SUBJECT: WATER RIGHT TRANSFER # 10316

Oregon Water Resources Department Memorandum

Date: 8 March 2007
To: Transfer Section and Application File G-5618 and Transfer File T-10316
From: Jerry Grondin, OWRD Hydrogeologist
Subject: Ground Water Transfer Technical Review
Application Number: G-5618
Permit Number: G-5457
Certificate Number: 74895
Transfer Number: T-10316
Transfer Applicant: Daniel & Tammy Shuck

KLAMATH
10268

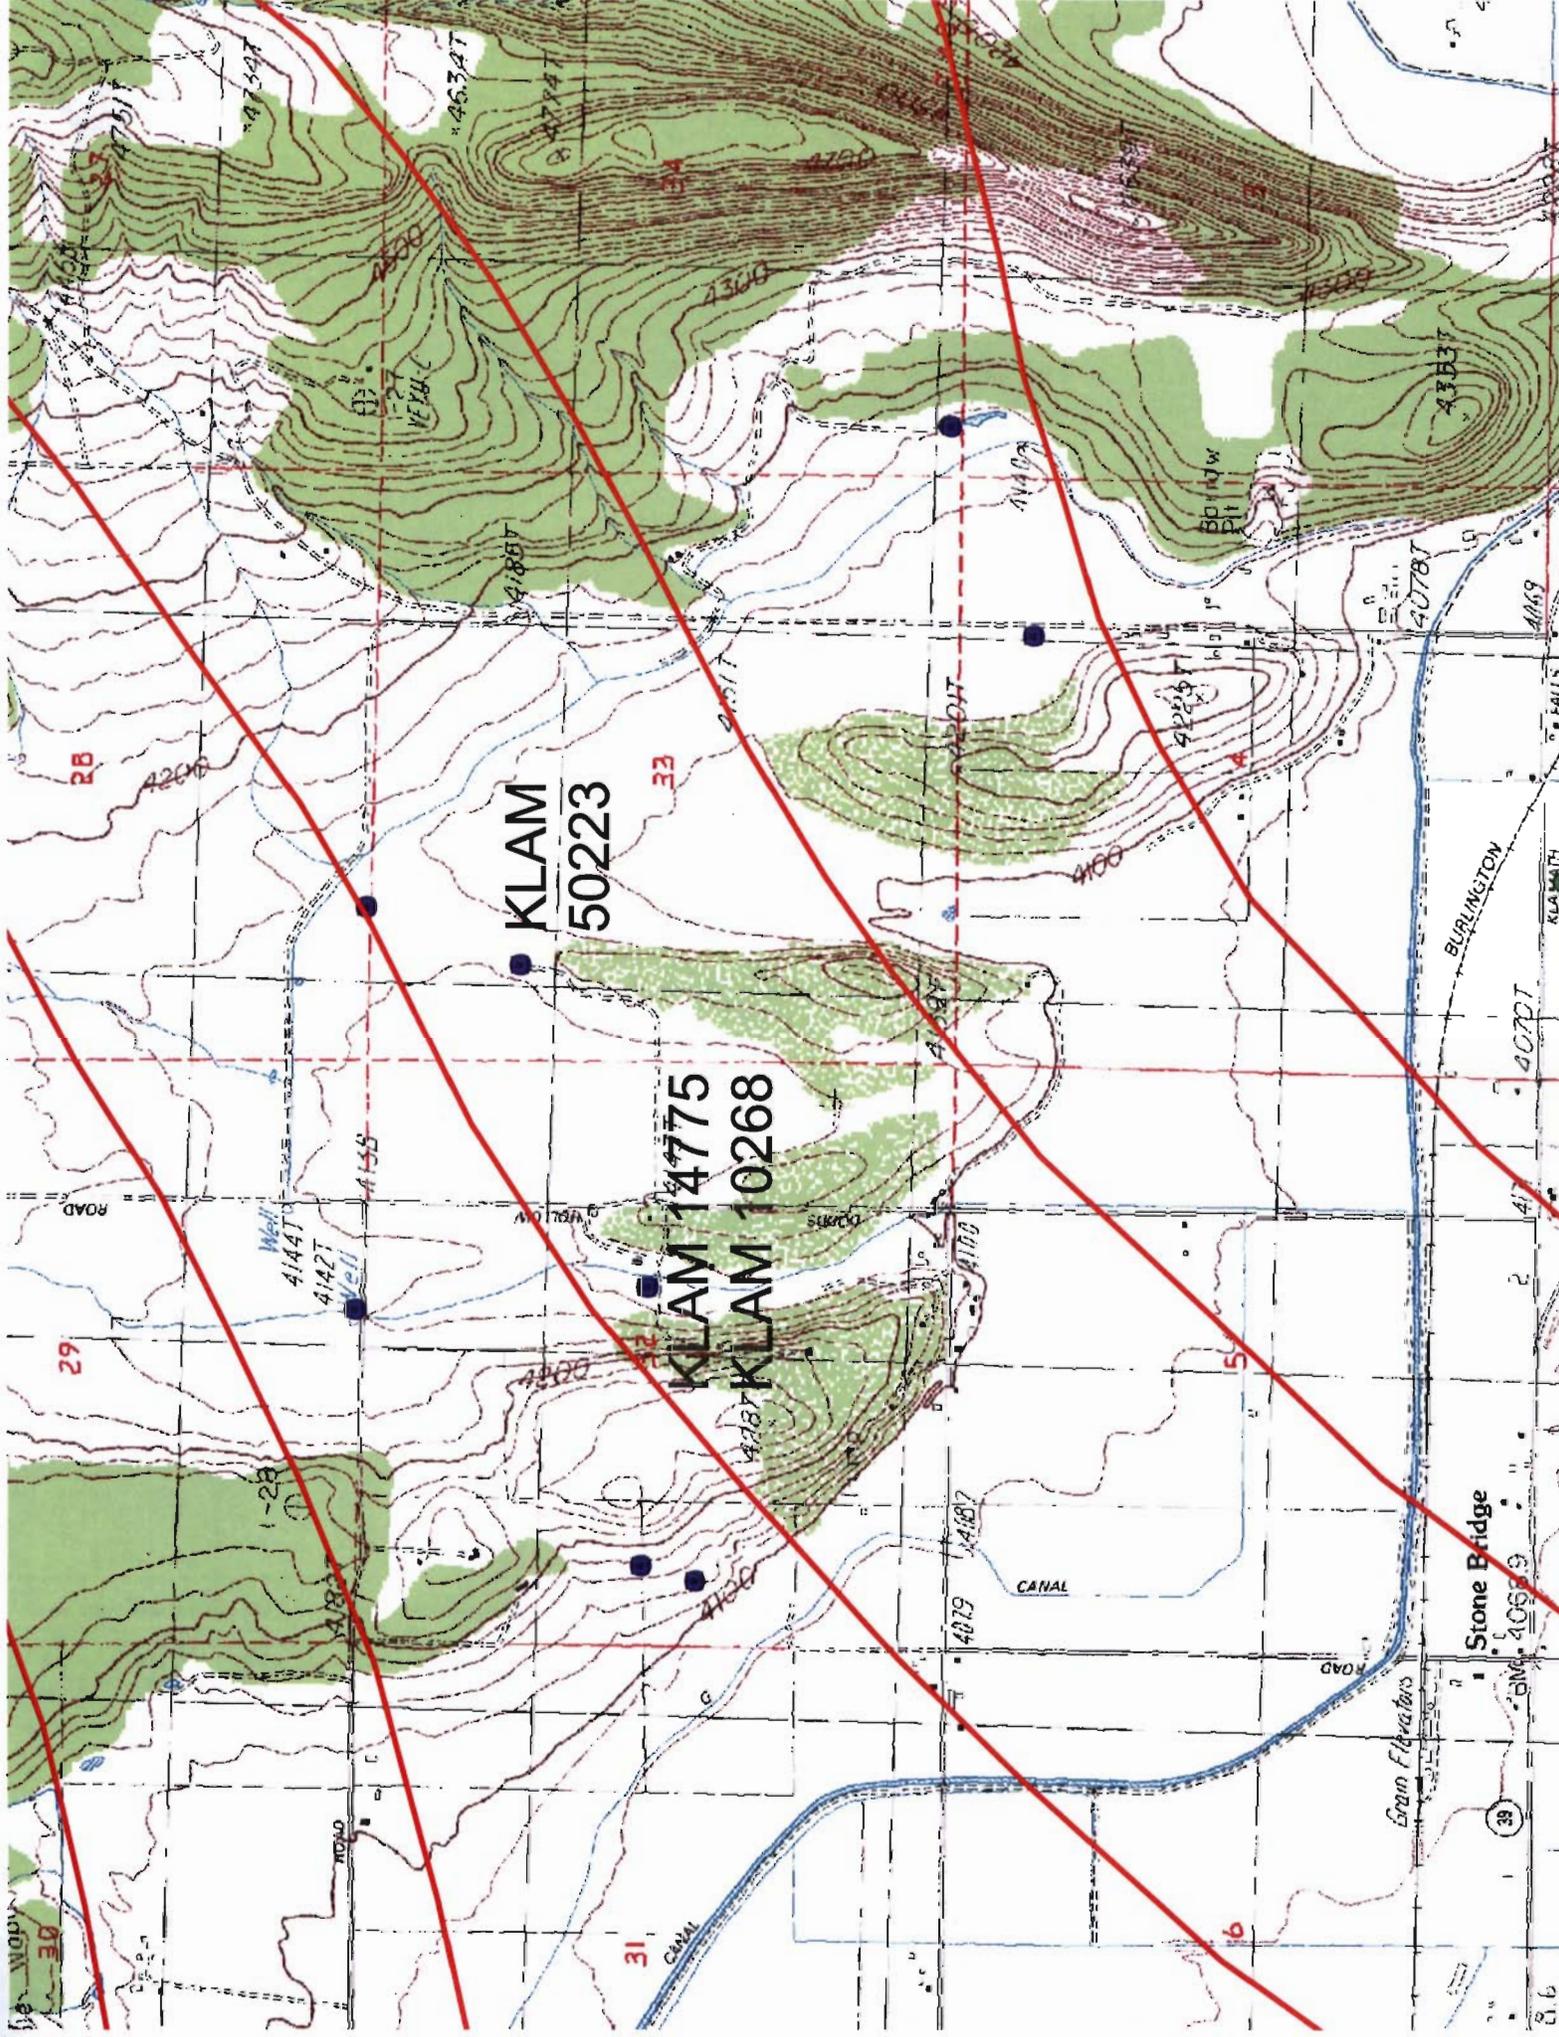
The well identified at the current POA by the transfer application and the water right application is KLAM 14775 constructed in 1958. However, the actual well being used appears to have changed to KLAM 10268 constructed in 1991 and located 22 feet from KLAM 14775 (see history below). The well identified at the proposed new POA is well KLAM 50223.

05 July 2000 Charles Shuck verbally confirms to OWRD staff that KLAM 14775 is not fixed, but replaced by KLAM 10268 located 22 feet away (an “informal transfer”)

Notes in water right file G-5618 indicates an “informal transfer” from well KLAM 14775 to well KLAM 10268 occurred due to problems with well KLAM 14775. The wells are 22 feet apart.

Existing well KLAM 14775 shall be properly abandoned before use of the new POA well begins.
